SEWAGE DISPOSAL SYSTEM

HOWARD COUNTY HEALTH DEPARTMENT

SUBDIVISION Waterford I LOT NUMBER 5 ADDRESS 13180 Brighton Dam Road

REPAIR - PURPOSE - To replace off-lot septic system with on-lot system.

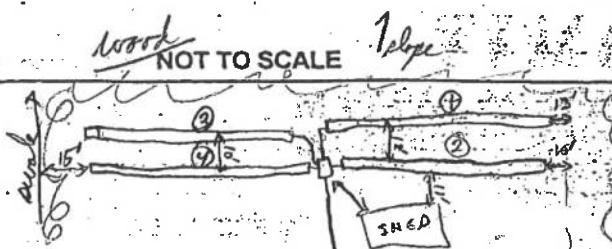
PRE-CONSTRUCTION INSPECTION: EXISTING TANK UNCOVERED, RE PLUMBED

ADDITIONAL TANK TO BE ADDED IN SEAMS (EXISTING TANK DISCONNECTED FROM OFF SITE DRAINFIELD)

INSPECTION COMMENTS: Trenches layed out, gravelled & pooped already - ends of Tr 1 & 2 only have 12-16" of soil cover below original grade while Tr 3 & 4 have paper had 4' below grade. Did Box OK cover, installer plans to add several feet of fill over ends of Tr 1 & 2 or should have 3 ft + cover over ends of trenches then I told him to make sure soil cap extends at least 5 ft. OK to cover all wood when finished. PIP 9/14/00
